April 14, 2018

To the Respected Members of the Council on Environmental Quality,

As a concerned Connecticut citizen, it is my hope that state environmental experts may answer some of the questions regarding future water quality and quantity raised by the Lenard study:

The land south of the New Britain parcel belongs to Tilcon, and will likely be mined in future years if this deal goes through. Figure 3-7 (Adobe page 48)

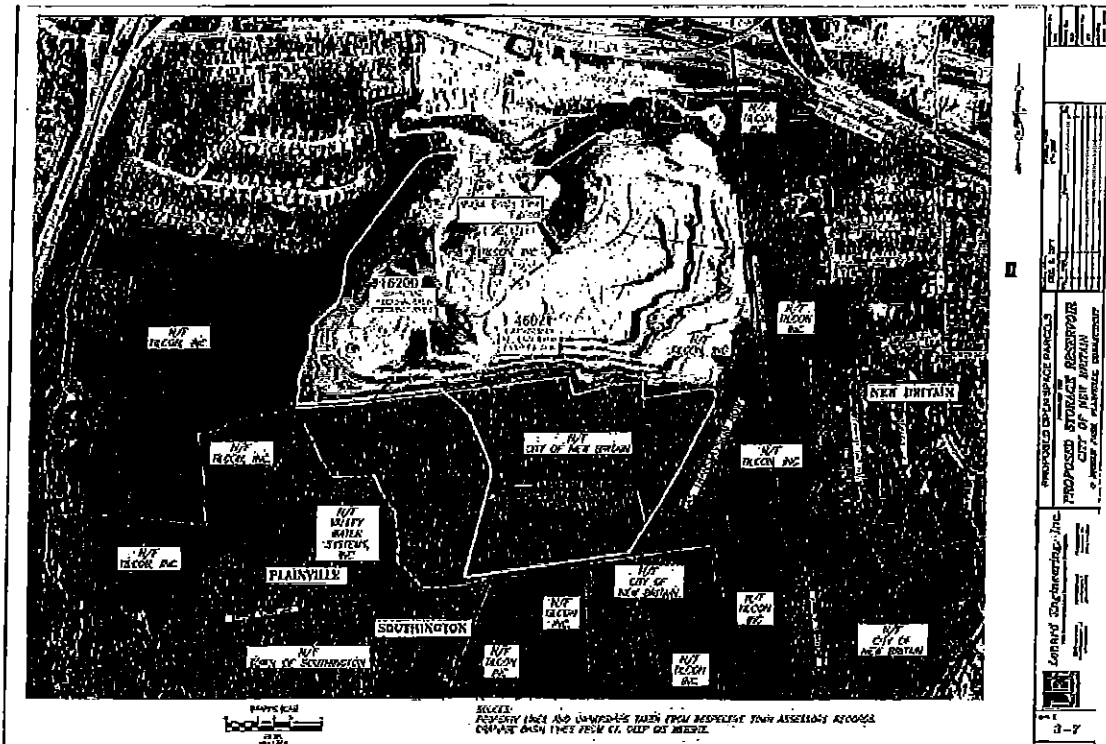
During their public testimony for Act 16-61, Tilcon presented misleading and inaccurate maps and numerical information regarding the proposed "deal." Again in the Lenard study, the map which is purported to show the land they will donate to Plainville, New Britain, and Southington (figure 3-7, Adobe page 45) does not appear to show what land is to be donated to each town. It appears to be a general map showing who owns each parcel of land.

**On the maps, it should be noted that once Tilcon mines New Britain's protected watershed land, they will then have access to their land just south of the parcel, and will likely petition to mine that as well. Currently, their access to that land is blocked off by the New Britain parcel.**

Additionally, this final version of the Lenard study now states that Tilcon will NOT mine the western 44 acres of the parcel, in order to preserve natural habitats. This is unlikely to be true. Tilcon has spent the last decade and untold resources lobbying to change state environmental law to get onto this land. They have spent more than a decade and innumerable resources in court weakening the DEEP's oversight of mining and effects on surrounding environment. [http://www.ct.gov/ceq/lib/ceq/Stormwater\\_and\\_Earthmoving\\_Report\\_-\\_Discussion\\_Draft\\_12-02-15.pdf](http://www.ct.gov/ceq/lib/ceq/Stormwater_and_Earthmoving_Report_-_Discussion_Draft_12-02-15.pdf) (page 10, State Regulation of Mining). It is really impossible to believe that they won't come back and mine as much of this land as they can in the future, perhaps when this study has long been forgotten, and a new generation of citizens and leaders have replaced us.
